UNITED STATES PATENT AND TRADEMARK OFFICE

APPLICATION NO.	FILING DATE	FIRST NAMED INVENTOR	ATTORNEY DOCKET NO.	CONFIRMATION NO.
10/813,199	03/29/2004	John J. Park	1022-2	5156
7590	08/04/2005		EXAMINER	
THE MARTINEZ GROUP PLLC/ Mark Sgantzos Suite 1-D 55 Poplar Street Brooklyn, NY 11201-6930			WONG, STEVEN B	
			ART UNIT	PAPER NUMBER
			3711	
DATE MAILED: 08/04/2005

Office Action Summary	Application No.	Applicant(s)	
	10/813,199	PARK, JOHN J.	
	Examiner	Art Unit	
	Steven Wong	3711

FIG. 10

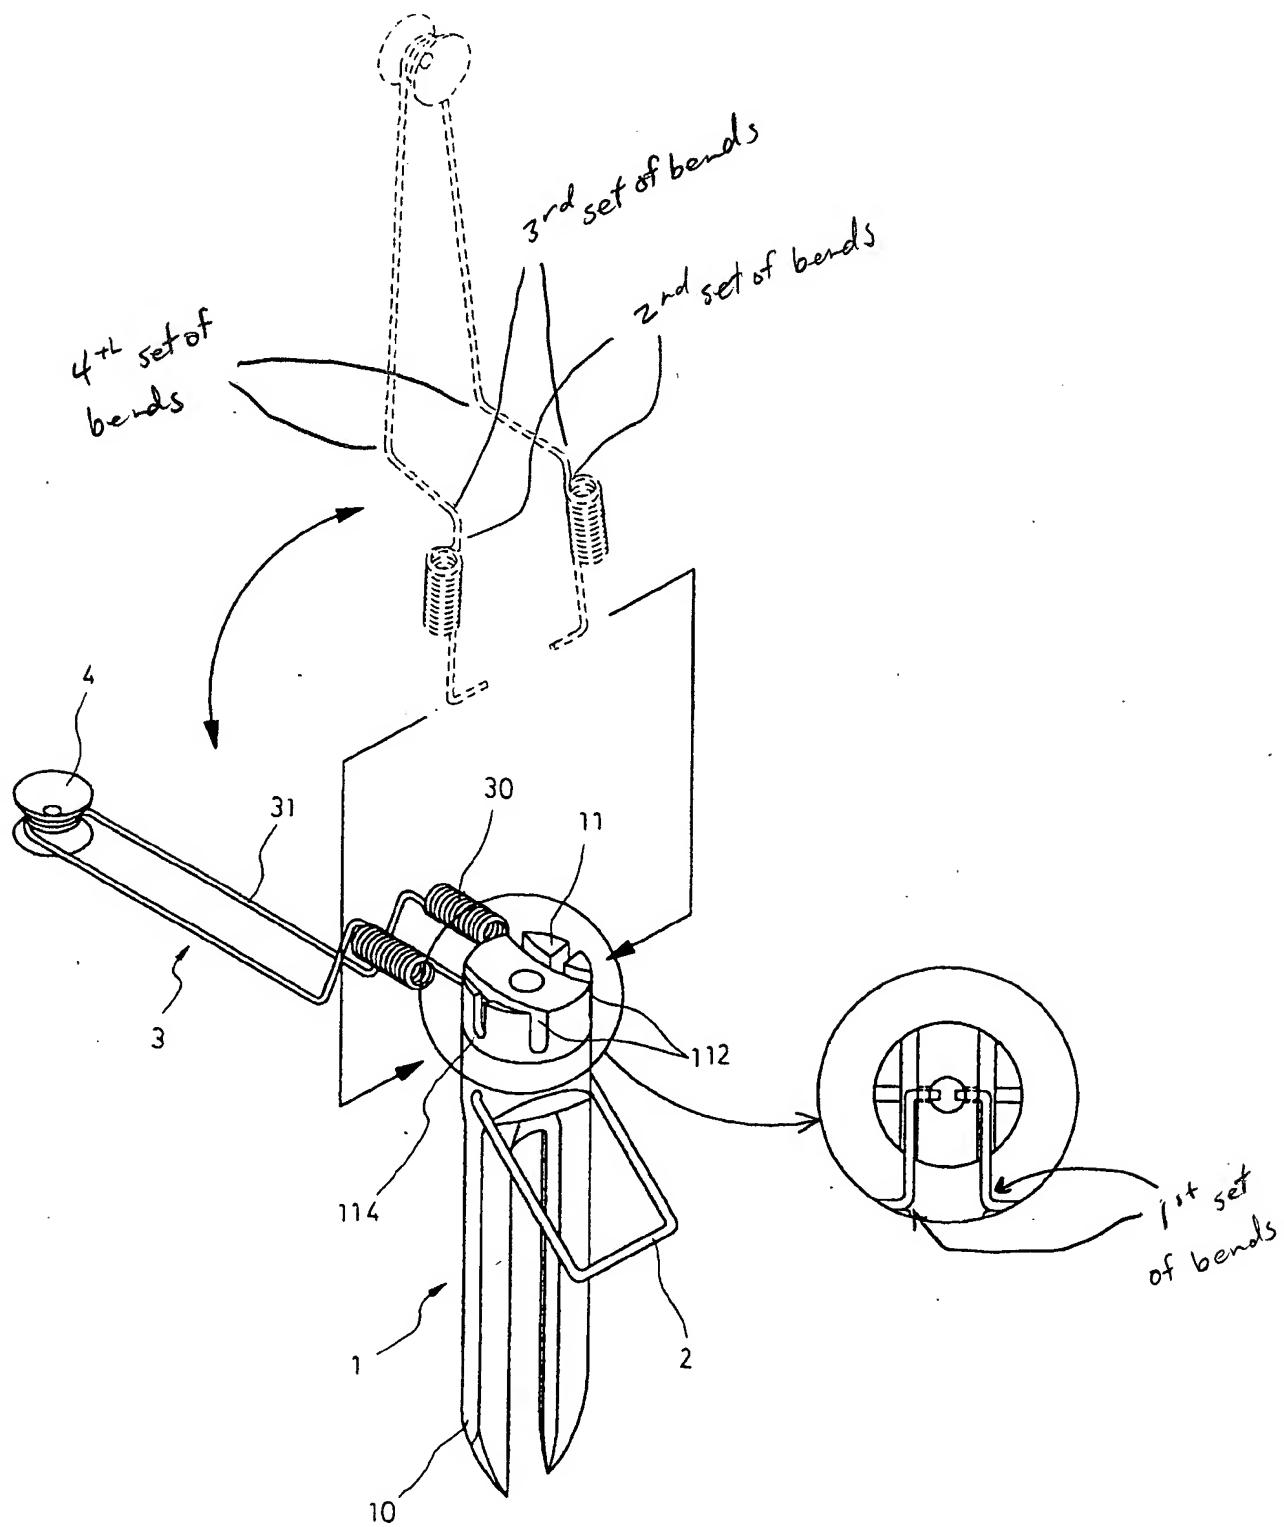
2. Claims 1, 3, 4, 10 and 12-14 are rejected under 35 U.S.C. 102(b) as being anticipated by Wei (6,500,077). Attention is directed to the bases for the rejections set forth in the Office Action mailed February 25, 2005. Regarding the added limitation to claims 1 and 10, Wei provides a series of bends in the wire for attaching to the golf seat (4). Attention is directed to the attached definition for “fold” stating that a fold is “a coil or bend, as of rope”. Therefore, one of the bends in the rope is seen as a fold. Regarding the limitation for four sets of bends forming a strike portion and a spoon shape portion, immediately after the spring Wei provides two sets of bends for the support. Further, the set of springs provide a series of bends for the wire support. Note specifically, the inset picture and dotted lines of Figure 10 and the examiner’s notations provided herewith. Immediately before and after the springs are bends for the wire support.

Regarding the limitation for the spoon shaped portion, the bends supporting the seat (4) define the spoon shaped portion. The claims fail to state that the golf ball rests directly on the

wire support. As such, a golf ball seated on the seat (4) that is supported by the wire meets the claim limitations.

Regarding the applicant's argument that Wei does not provide four bends in his wire nor does he provide a fold, attention is directed to the basis for the rejection set forth above. Applicant provides his own definition for "fold"; however, he does not provide any dictionary citation therefore. Also, applicant fails to provide any antecedent basis in the specification for the term "fold" and therefore, does not provide any positive definition for the term. Regarding the limitation for four bends in the wire, note the interpretation of the wire support of Wei stated above where it is found to comprise four sets of bends.
